ADDENDUM

Project Name:	Village of Beverly Hills Village Hall Office Renovation	Addendum No:	One (1)
Project Number:	15-161	Issue Date:	April 15, 2015
Project Location:	The Village of Beverly Hills, Michigan

To the Contract Documents for the requested Village of Beverly Hills Village Hall Office Renovation.

8
A3-02

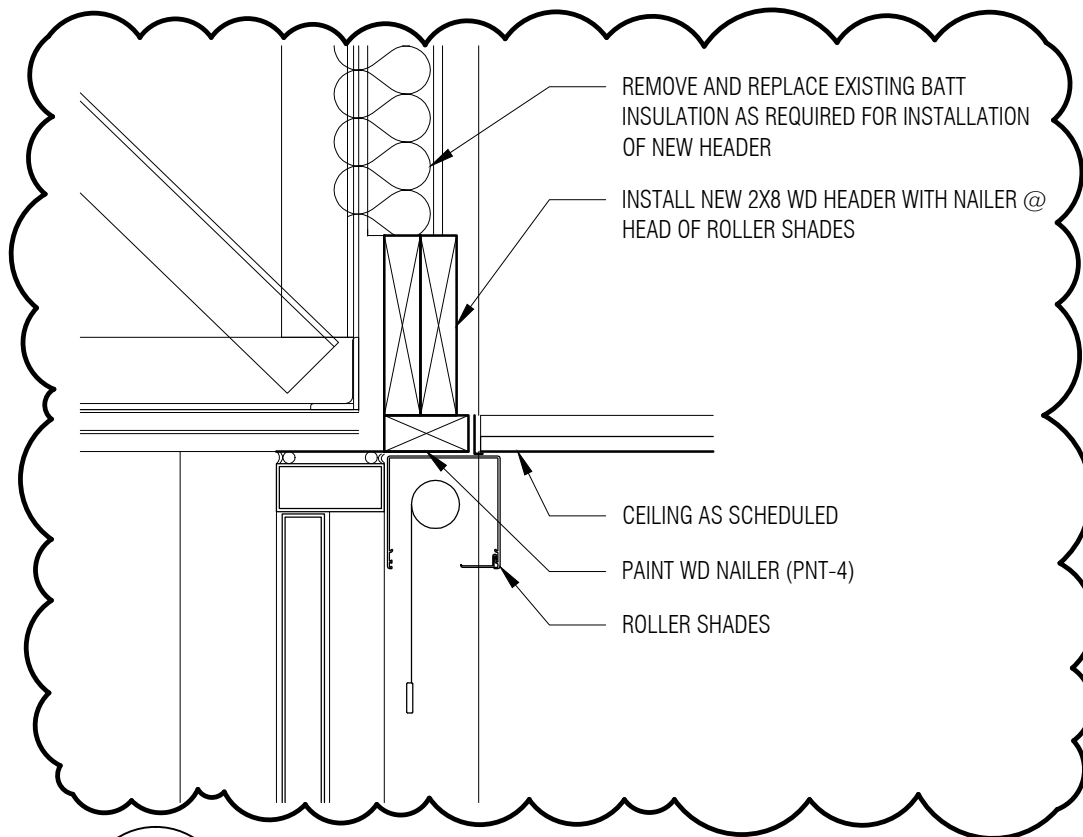
- Item A5** Drawing A3-10; Enlarged Floor Plans (not reissued this addendum) & SK-02; Plan Detail 8/A3-02 (issued this Addendum)
- A. Revised Plan Detail 8/A3-02; for partition to exterior window detail.
